## ANN ARBOR HISTORIC DISTRICT COMMISSION

### Staff Report

**ADDRESS:** 822 W Jefferson Street, Application Number HDC15-038

**APPLICATION:** The applicant seeks HDC approval to construct a new two-story home on the lot and remove a landmark tree.

West Elevation

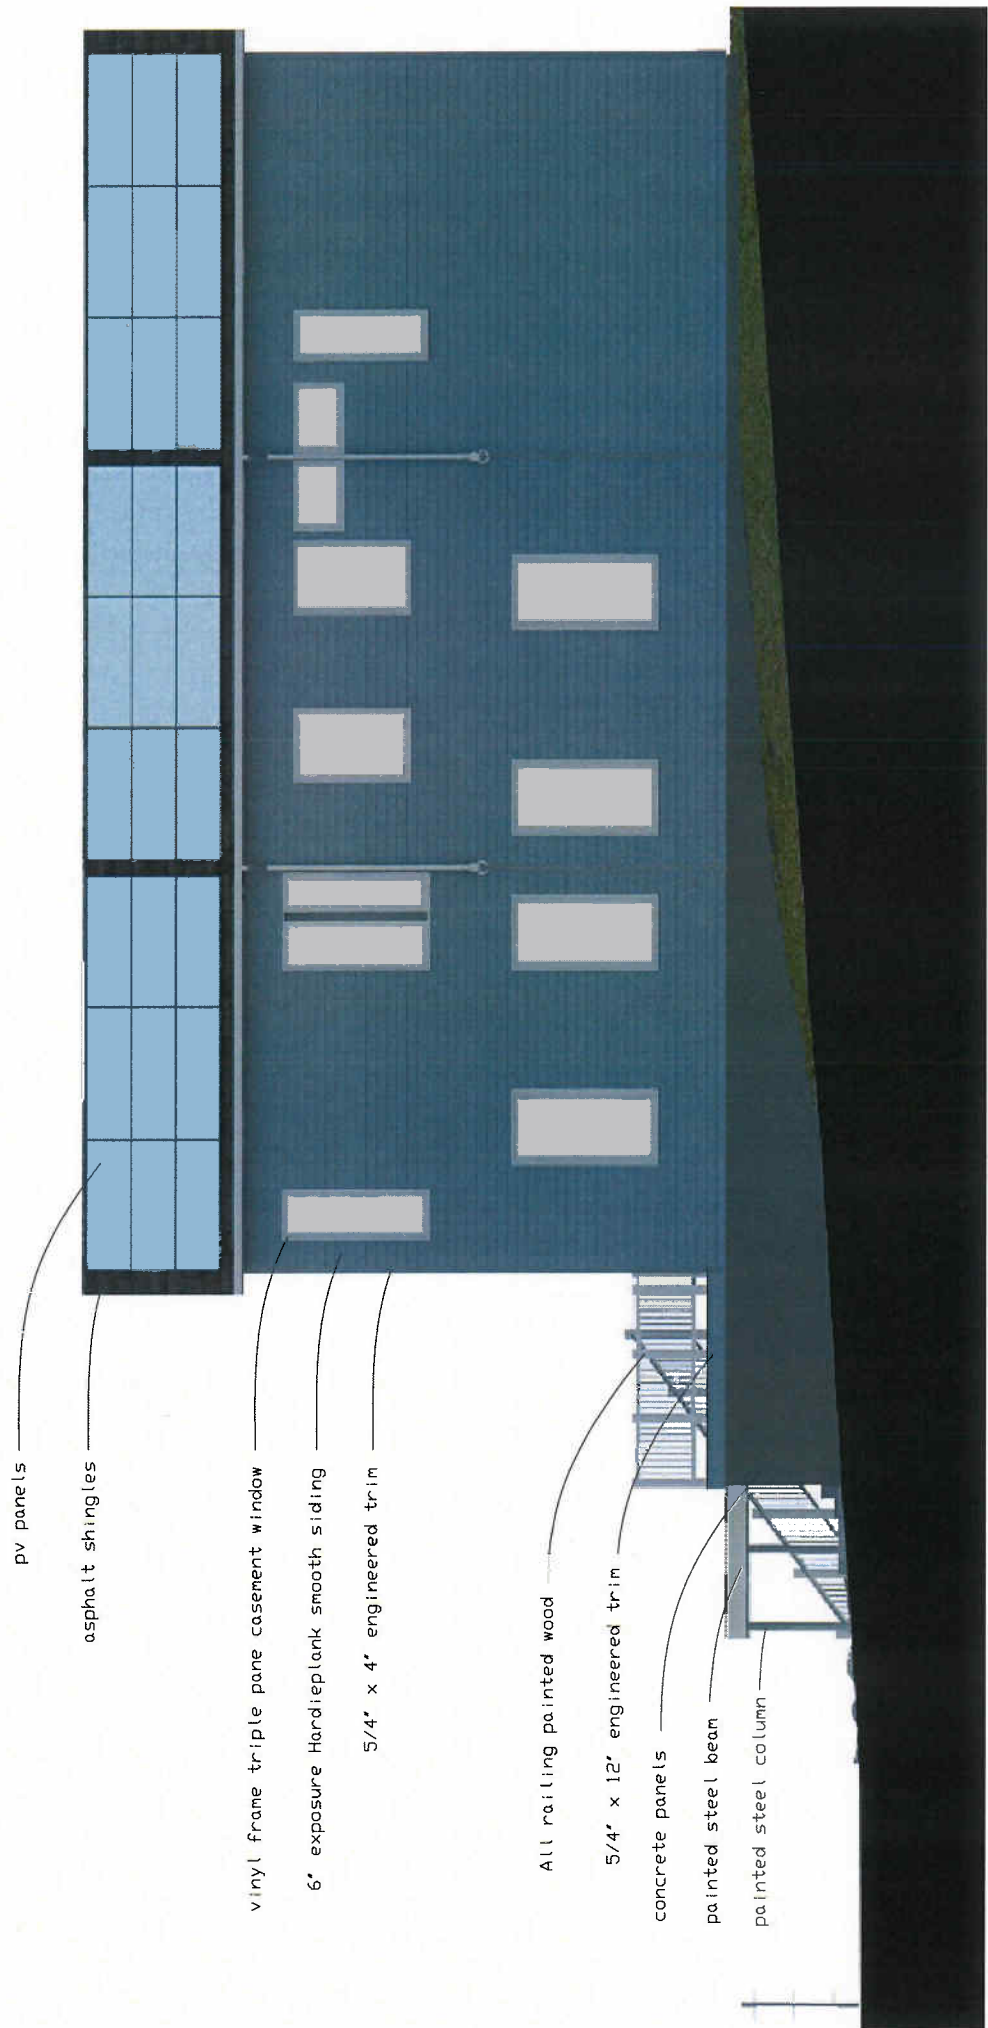
4. The west side elevation (facing South Seventh), is more modern in appearance, mainly because of the irregular size and spacing of the second floor windows. The lot slopes and is about seven feet higher in the front than at the back, This allows a driveway off South

Seventh and a garage partially underneath the house. On top of the other part of the garage is a deck accessed from the main floor of the house, and a stairway leading down to the backyard.
